## CVS DISTRIBUTION CENTER SITE IMPROVEMENTS JSP23-45

Public Hearing at the request of the CVS Distribution Center for Preliminary Site Plan, Woodland Permit, and Stormwater Management Plan approval. The subject property is zoned I-1, Light Industrial and is located at 43600 Gen Mar, west of Novi Road, on the north side of Gen Mar. The applicant proposes to construct a 56-space employee parking lot east of the CVS Distribution property and is seeking approval to remove 7 regulated woodland trees.

Merjent, Inc. (Merjent) has conducted a review of the re-revised preliminary site plan (rrPSP) for the CVS Distribution Center Improvements (also referred to as 43800 Gen Mar Road; site) prepared by PEA Group (rev. date 6/26/2024). The site (parcels 50-22-22-276-008 and 50-22-22-276-009) contains City-regulated woodlands (**Figure 1**) and City-regulated wetlands (**Figure 2**).

DRAWING TITLE PRELIMINARY GRADING PLAN

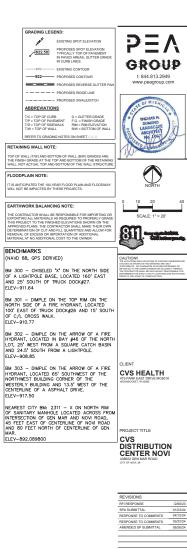
- b. The location and extent of tree protection fence should be added to the site plan prior to final site plan approval. This can be added to sheets that indicate grading or construction activities (Sheet C-4.0 and/or Sheet C-5.0) and/or landscape activities (Sheet T-1.0).

PEA JOB NO.	2023-0758
	P.M.	TD
	DN.	CD
	DES.	CD
	DRAWING NUMBER:	
UCTION	C-8	.0

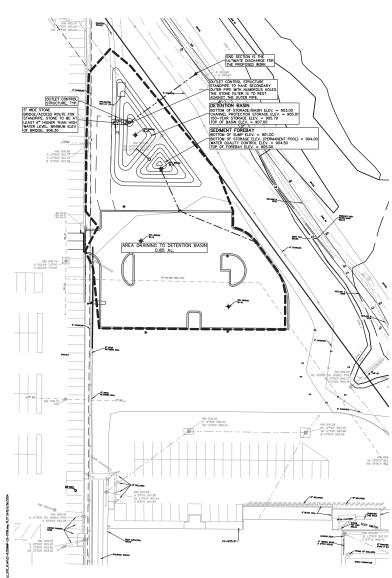
- 9. Show the contour line elevations on sheet C-8.0.
- 10. The calculations are currently stating the 100-year storage elevation is 905.79', whereas the outside elevation of the detention basin is at 905'. This would mean that the 100-year storage is not contained in the detention basin alone and would overflow back into the sediment forebay and the rest of the basin complex. Please revise the detention basin elevations to ensure that the 100-year storage volume will be self-contained in the Detention Basin.
